Access Compliance Report

Public Rights-of-Way (Curb Ramps)

Intersection ID: 45241	Main Street: TALUS_TRACE_LN	Cross Street: TALUS_TRACE_LN	Location: SW
ADA ID: BD0C48D7CB68	Ramp Type: PerpDiag	Initial Pass/Fail: Fail	Overall Compliance: No
Severity Score: 13.75			
Codes/Mitigation Info/Possible Solution		Field Measurements/Component Compliance

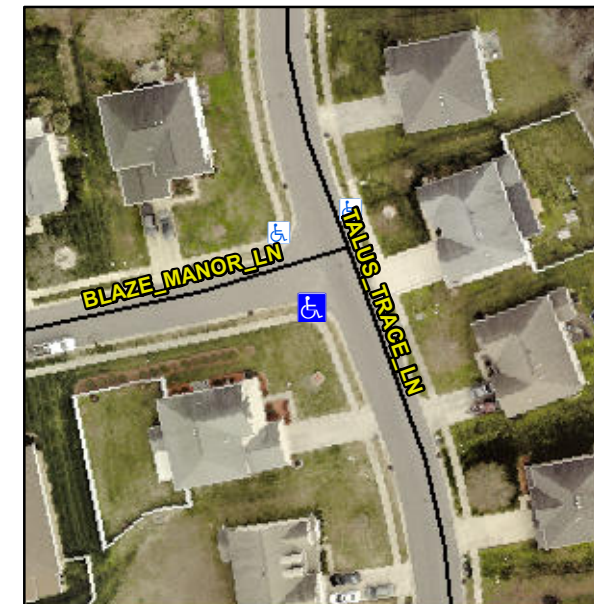
Not Found, R304.2.2, R304.5.3

Compliance	Description	Data	Compliance	Description	Data
N/A	Ramp Length (in)	45.5	No	Ramp Slope (%)	8.9
Yes	Ramp Width (in)	48.0	No	Ramp XSlope (%)	2.8
N/A	Flare Type LT	N/A	N/A	Flare Type RT	N/A
N/A	Flare Slope LT (%)	N/A	N/A	Flare Slope RT (%)	N/A
N/A	Flare Traversable LT?	N/A	N/A	Flare Traversable RT?	N/A
N/A	Landing Length (in)	N/A	N/A	DWS Provided?	N/A
N/A	Landing Width (in)	N/A	N/A	DWS Contrast?	N/A
N/A	Landing Slope (%)	N/A	N/A	DWS Length (in)	N/A
N/A	Landing X Slope (%)	N/A	N/A	DWS Full Width?	N/A
N/A	Landing Curb? (Y/N)	N/A	N/A	DWS Offset (in)	N/A
N/A	Shared Landing?	N/A			
N/A	Gutter Ponding?	N/A	N/A	Gutter Slope (%)	N/A
N/A	Gutter Lip Ht (in)	0.5	N/A	Gutter X Slope (%)	N/A
N/A	Painted X Walk1?	No	N/A	Painted X Walk2?	No
	X Walk 1 Direction	To E		X Walk 2 Direction	To N
N/A	X Walk 1 Width (in)	N/A	N/A	X Walk 2 Width (in)	N/A
	X Walk 1 Slope (%)	3.6		X Walk 2 Slope (%)	2.6
	X Walk 1 X Slope (%)	2.0		X Walk 2 X Slope (%)	0.6

N/A	Ramp inside XWalk1?	N/A	N/A	Ramp inside XWalk2?	N/A
	Road Slope (%)	2.2	N/A	Clear Space?	N/A
	Road X Slope (%)	1.9	N/A	Clear Space to XWalk (in)	N/A
N/A	Any Obstructions?	N/A	N/A	Storm Grate/Utility Hazard?	N/A
	Obstruction Type			Storm Grate/Utility Type	
		N/A			N/A
			Yes	Surface Condition? (G/P)	Good

Remove & Replace Curb Ramp With Two New Directional Ramps or Equivalent.
